Addendum No. 1

Bid Opportunity: 7159-RW-22 – Smithson PS Office and HVAC Upgrades.

Closing Date: Monday, March 14th, 2022 2:00 PM

1 EXISTING/DEMO SIGNALING DEVICE LAYOUT - WEST WING
E12 SCALE: 1:200

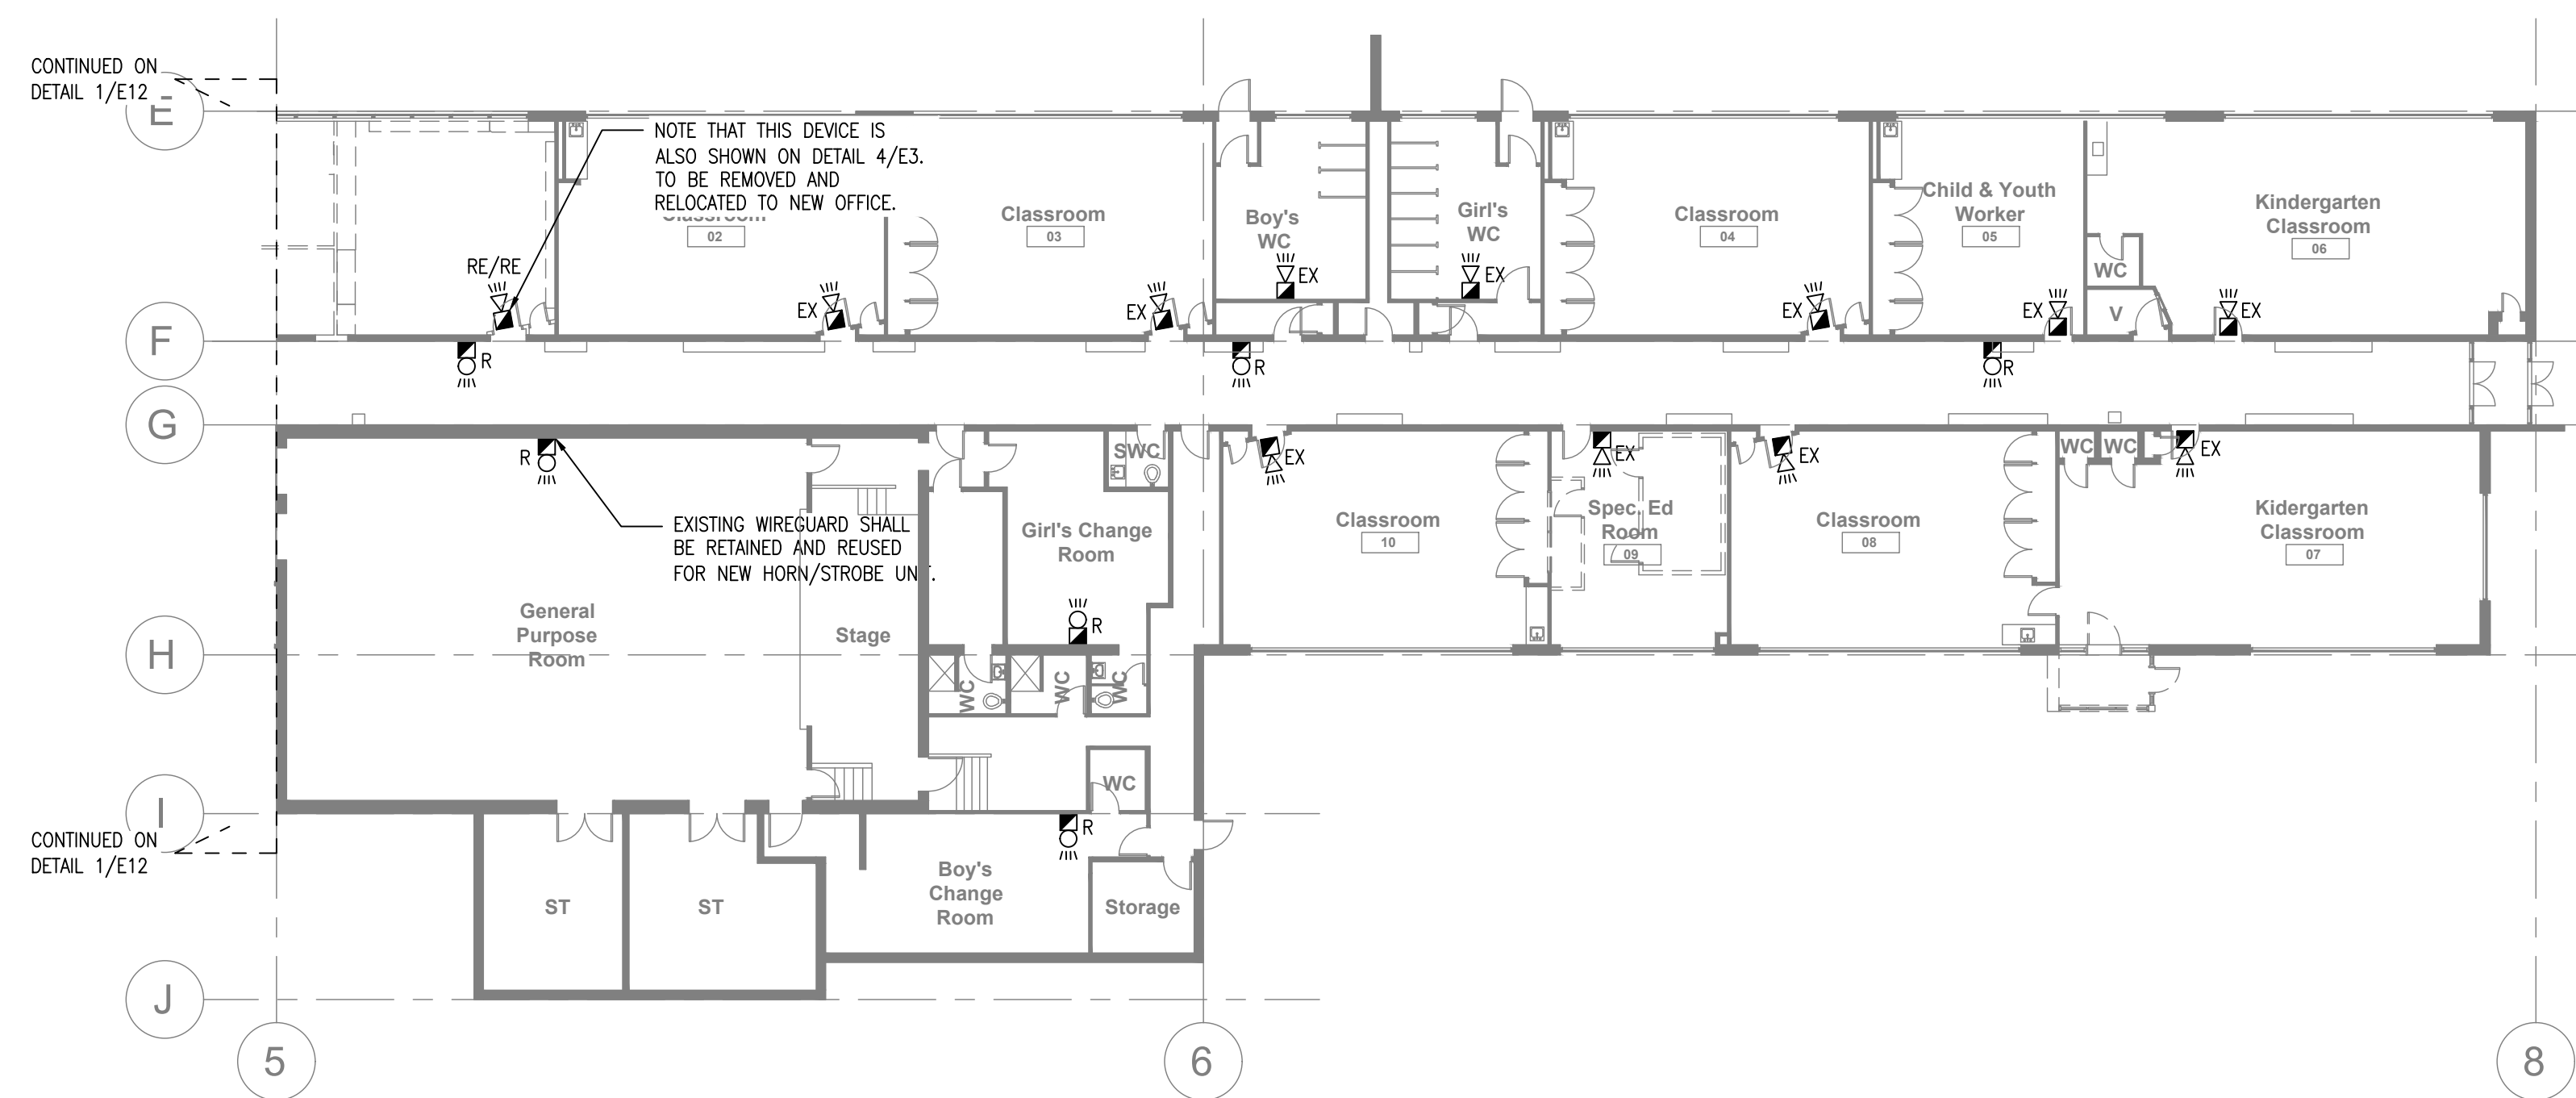
11. REFERENCE DRAWING E12 – EXISTING/DEMOLITION SIGNALING DEVICE LAYOUT (ISSUED FOR ADD-E01)

1. This drawing has been added to indicate the scope of work required to upgrade all existing bell/strobe combination units within the existing school. Refer to drawings for exact quantity and locations. Existing wiring to be reused.

1 PROPOSED SIGNALING DEVICE LAYOUT - WEST WING
E12.1 SCALE: 1:200

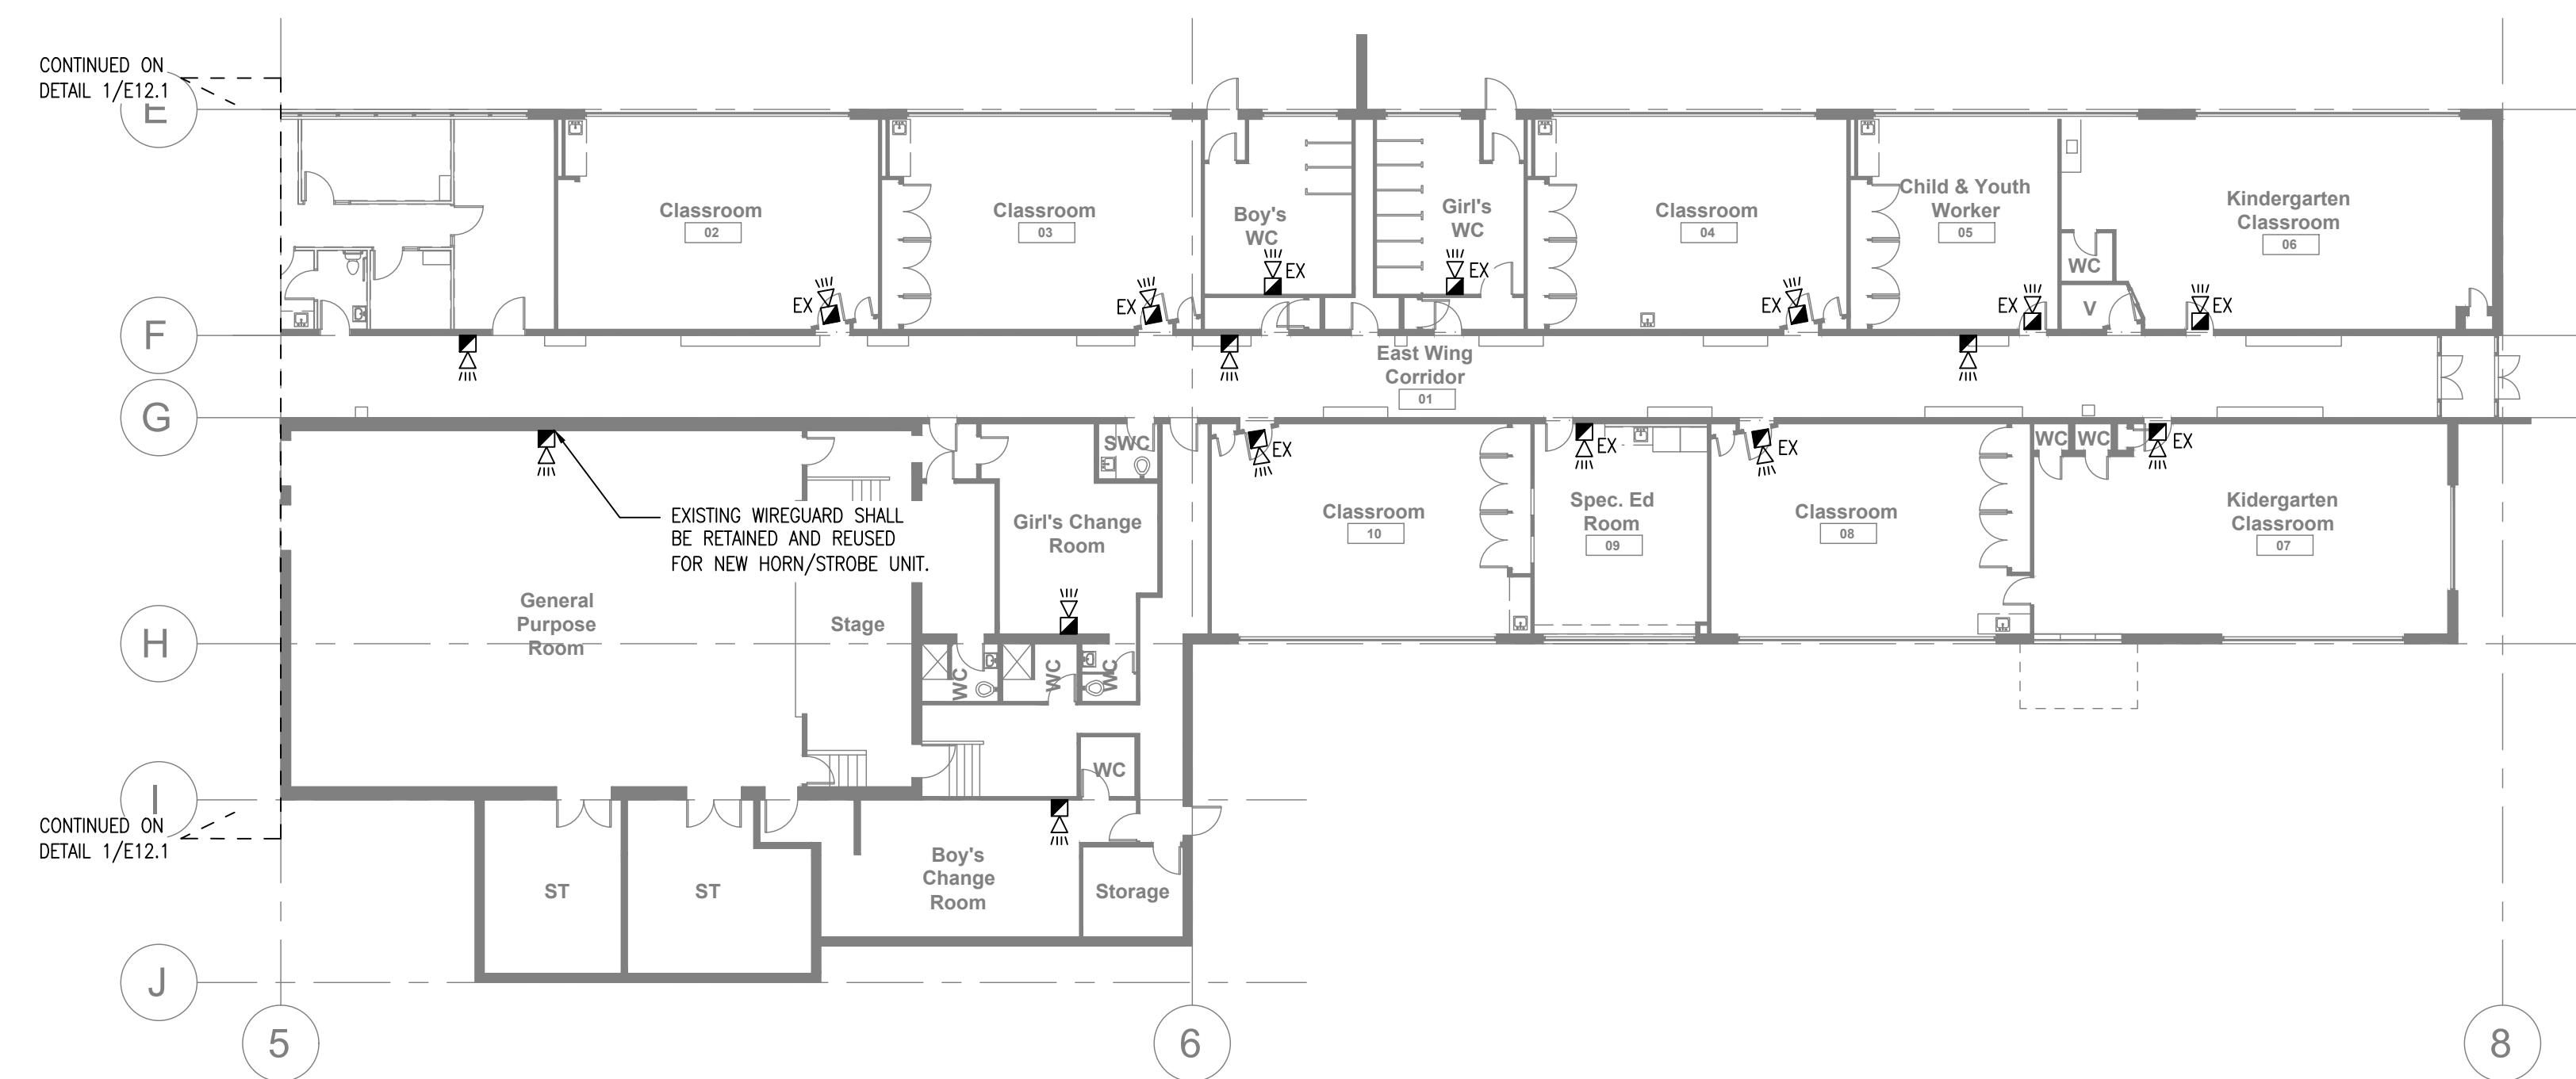
12. REFERENCE DRAWING E12.1 – PROPOSED SIGNALING DEVICE LAYOUT (ISSUED FOR ADD-E01)

-
1. This drawing has been added to indicate the scope of work required to upgrade all existing bell/strobe combination units within the existing school. Refer to drawings for exact quantity and locations.
